#PLN-2022-00238
SWC Bard Road and Huntley Road – Conceptual PUD
Project Review for Planning and Zoning Commission

<u>Meeting Date:</u>	November 16, 2022
<u>Request:</u>	Conceptual Planned Unit Development review for a 48-unit townhome development
<u>Location:</u>	Southwest Corner of Bard Road and Huntley Road
<u>Acreage:</u>	Approximately 5.3 acres
<u>Zoning:</u>	R-3B PUD Multi-Family Residential
<u>Surrounding Properties:</u>	North: R-2 Single-Family Residential and City Limits South: R-1 PUD Single-Family Residential East: B-1 PUD Neighborhood Business West: E Estate and R-3B PUD Multi-Family Residential
<u>Staff Contact:</u>	Katie Rivard (815.356.3612)

SITE PLAN 1" = 60'

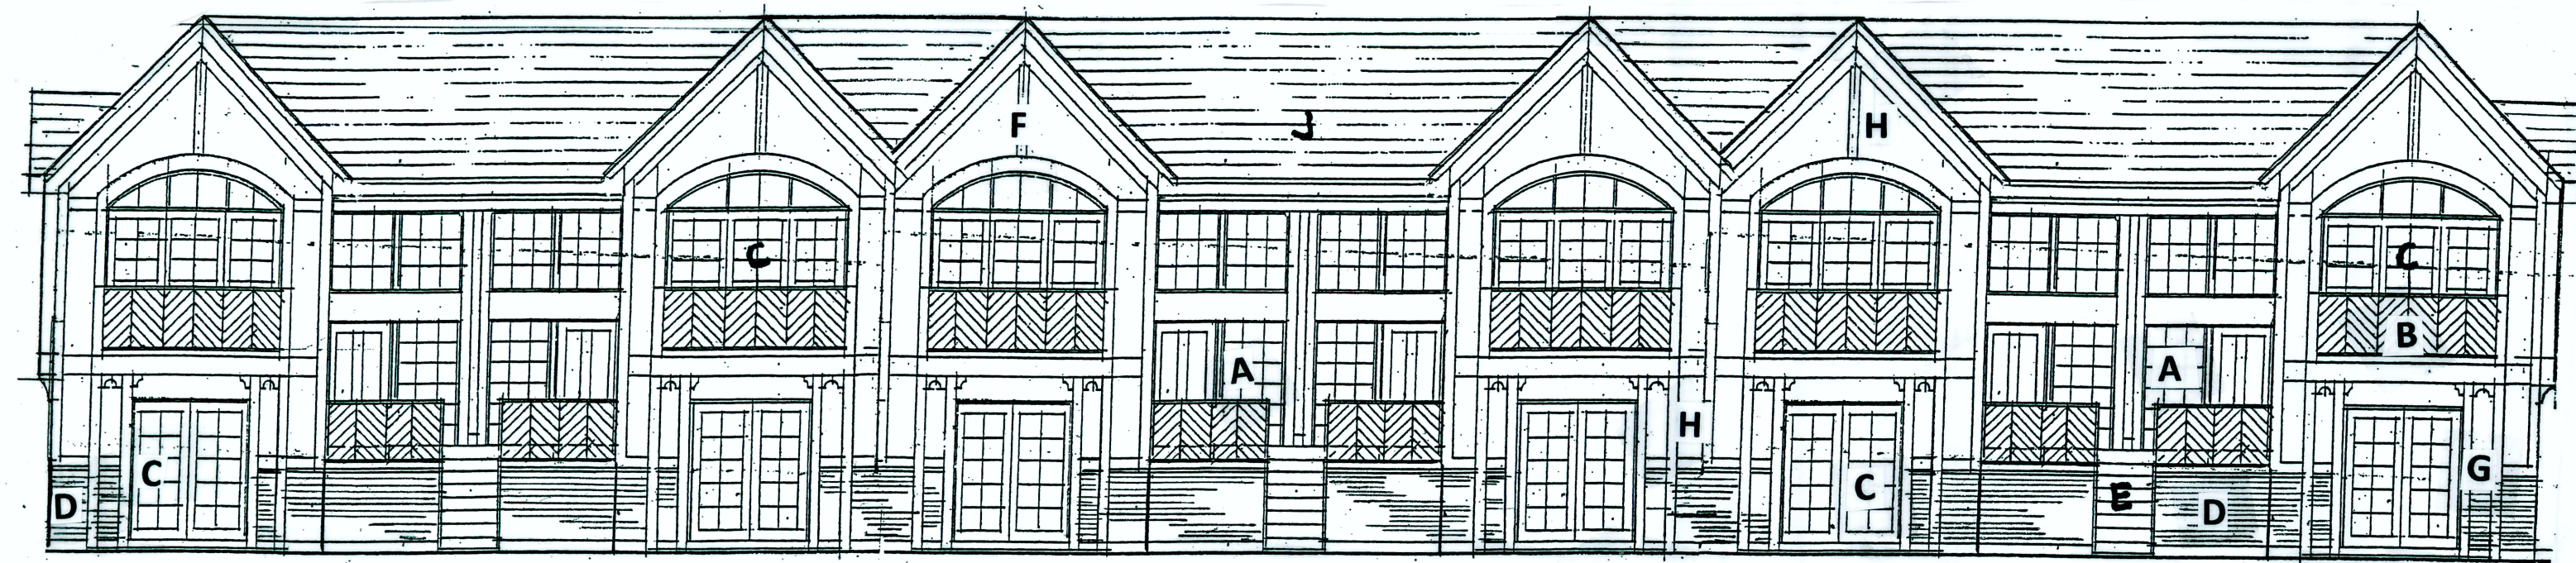
- The proposed development would consist of eight 2-story, townhome buildings with 8 units per pod for a total of 48 units.
- The R-3B zoning district permits 9 units to the net acre. The development is proposed at 48 units to the acre (9.1 dwellings units per acre). The developer would need a density variation or to acquire density in an alternate way.

- The proposed development complies with the setback requirements of the R-3B zoning district.

- A landscape plan will be required and it must comply with the landscape requirements (site landscaping, foundation plantings, buffer requirements, etc.) of the UDO of Section 4-400. The development will require a 20-foot landscape buffer from the adjacent residential development.
- The proposed impervious surface coverage is 32%, which meets the zoning district requirement of 65%.

- Access into the site would be provided off Bard Road and Huntley Road.
- The total width of the community drive aisles are 26 feet.
- The proposal includes the following amenities for residents:

- Green space throughout with courtyards between buildings;
- Gazebo area;
- Children's playground; and
- Dog park.
- Sidewalks do not currently exist along Bard Road and Huntley Road. Sidewalk connections are provided between buildings. Additional sidewalks from the children's playground to the dog park should be included.
- The detention area is located at the southeast corner of the property. This provides additional buffer and screening to the single-family residential to the south.
- A traffic study is not required for this development.

- Each unit will have two garage spaces for a total of 96 garage parking spaces. There will be an additional 38 parking spaces throughout the site. Parking stall depth and width will need to meet the UDO requirements.
- Based on the submitted plans, 108 parking spaces would be required for the residential units (2.25 spaces per 2-bedroom unit) and 134 spaces are provided.

FRONT ELEVATION 1/8" = 1' - 0"

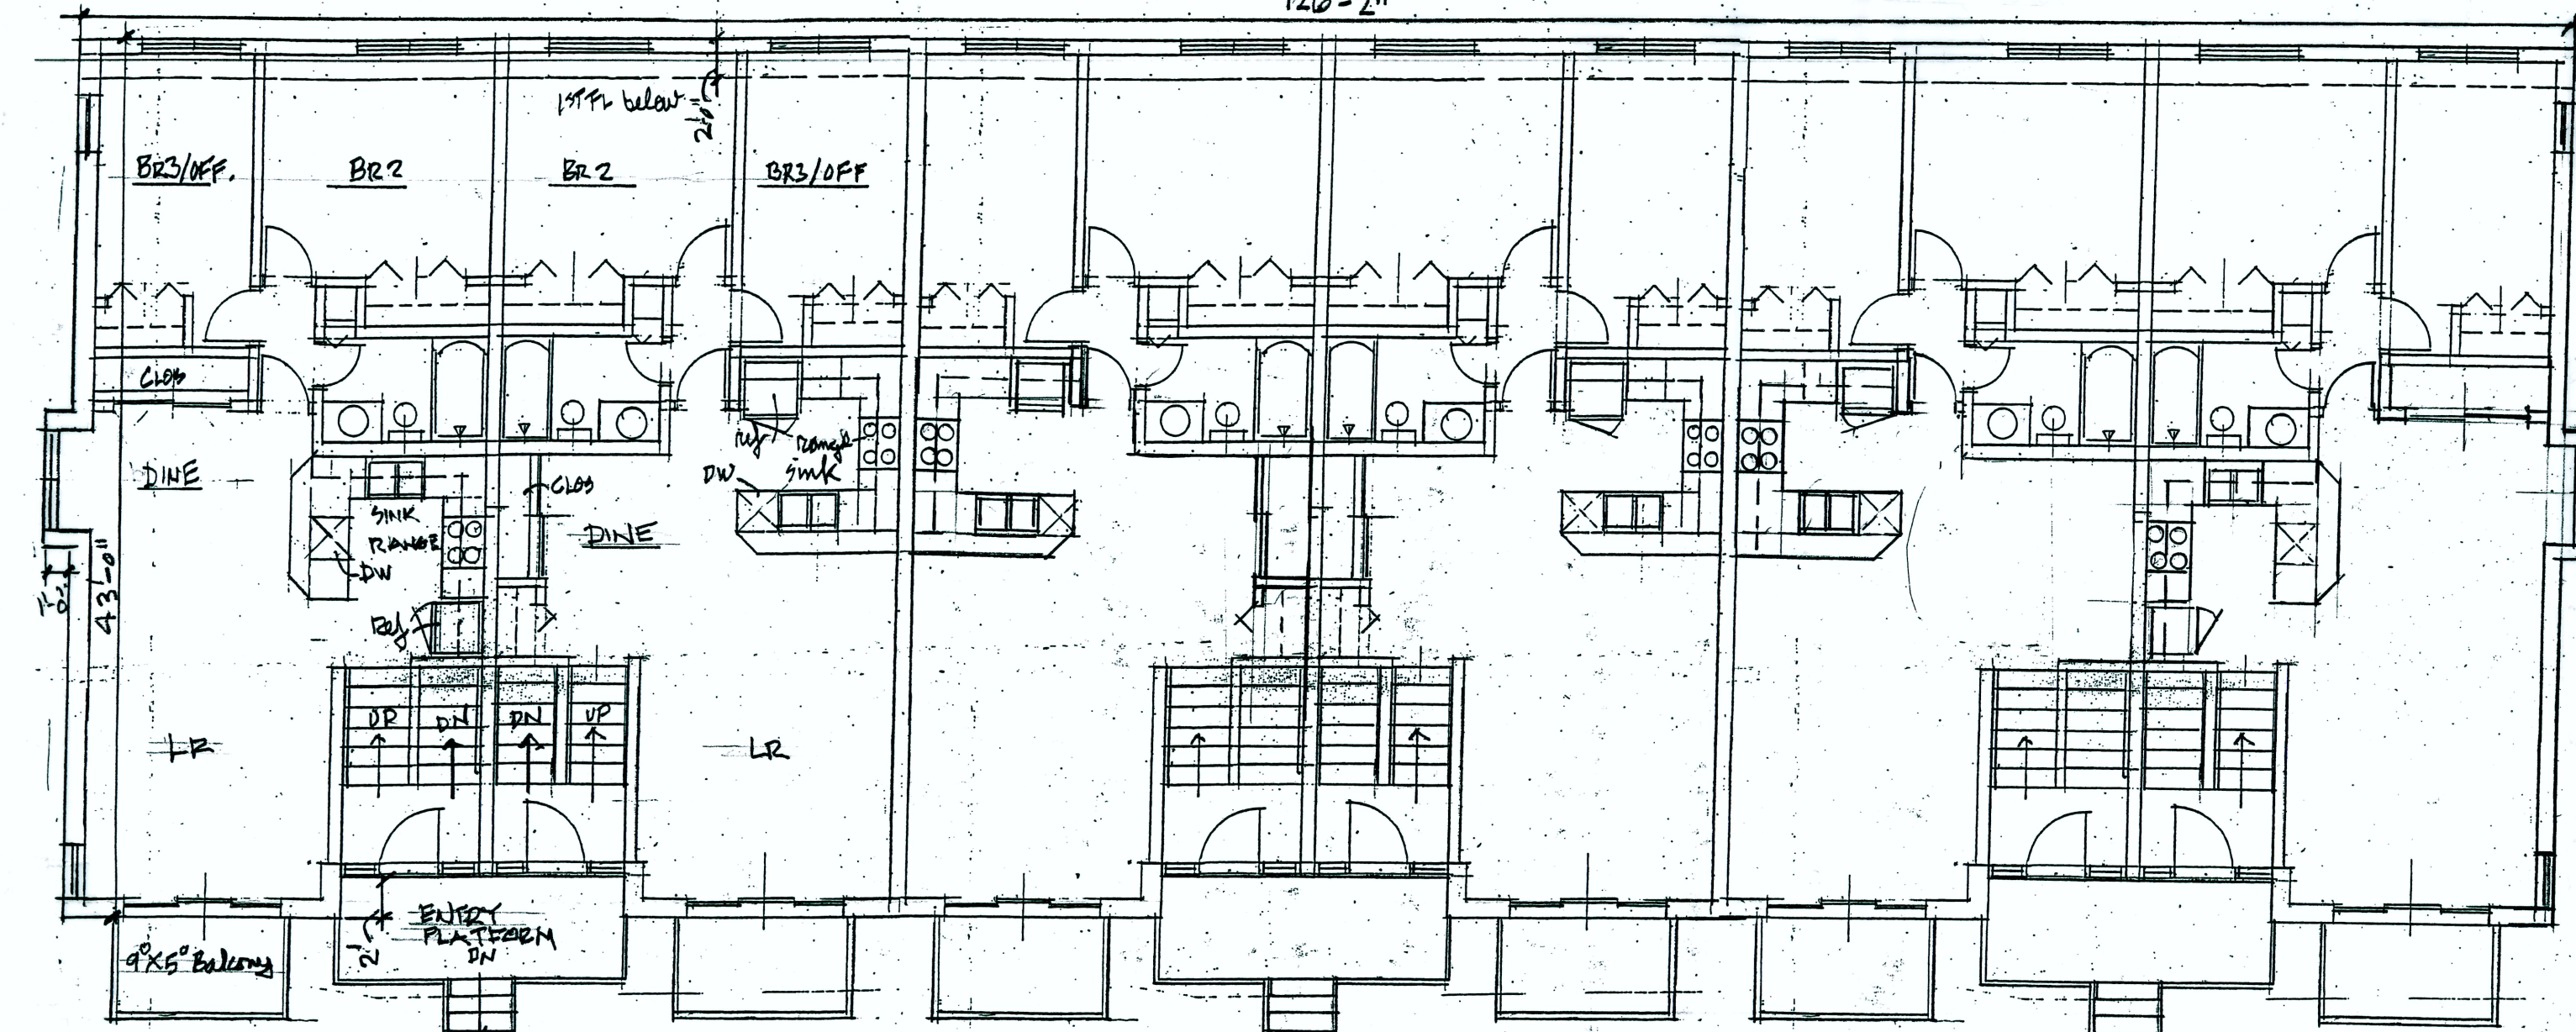
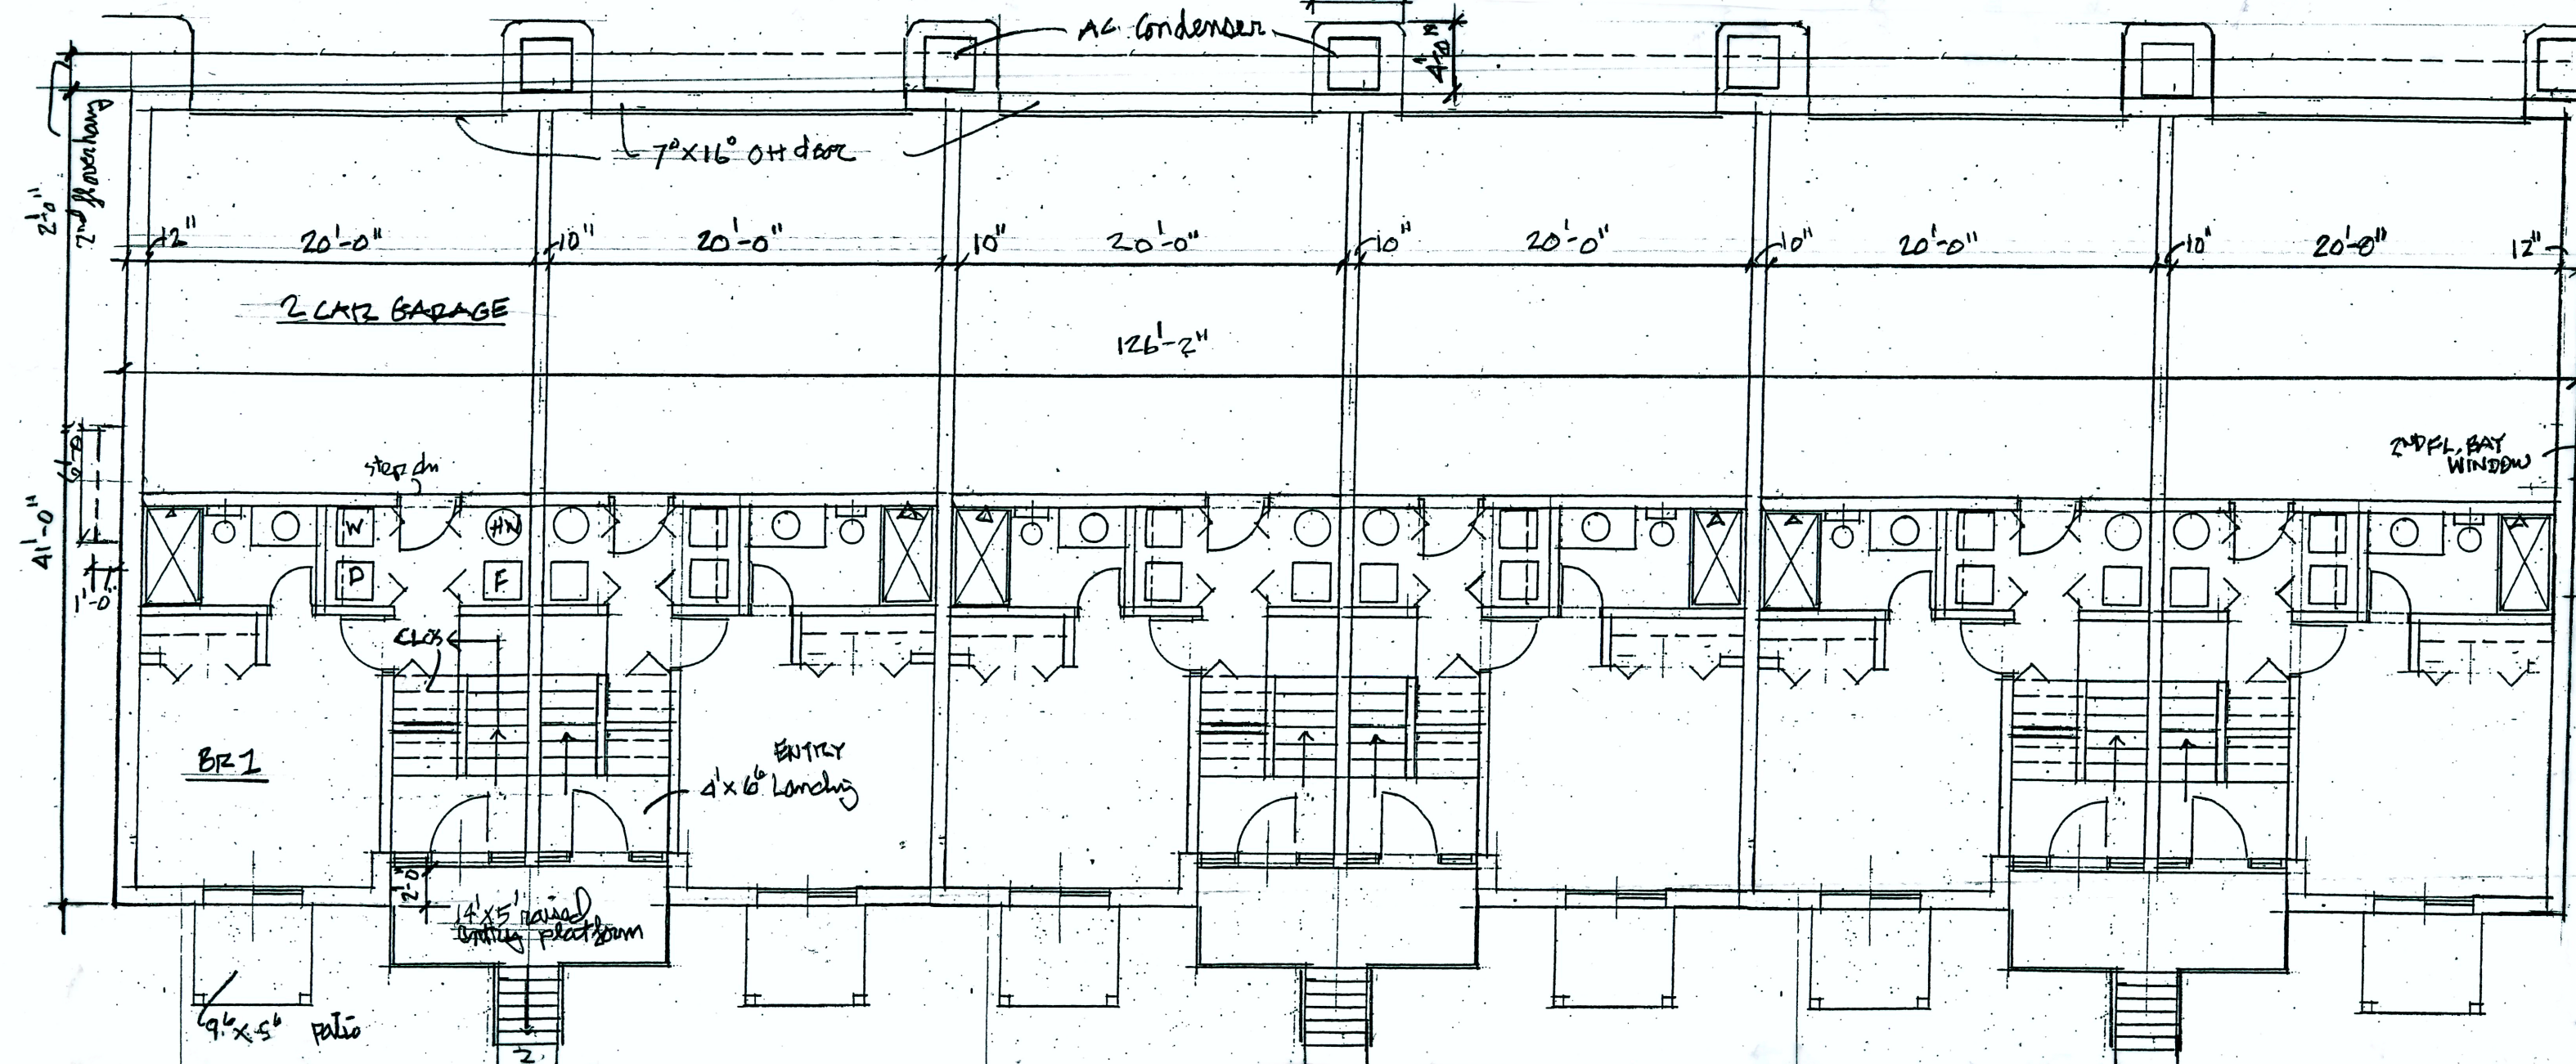
- The buildings are 2-story with a combination of brick and textured flush Hardie Board siding.
- Each unit will have a rear loading garage and a private patio in front of the townhome facing the courtyards.
- The proposed architecture includes the following architectural accents:
 - Gable brackets;
 - Varying windows sizes;
 - Bronze balcony railings;
 - Balcony brackets;
 - Craftsman's style window trim;
 - Recessed entryways;
 - Combination of Hardi board and brick; and,
 - Neutral color scheme.
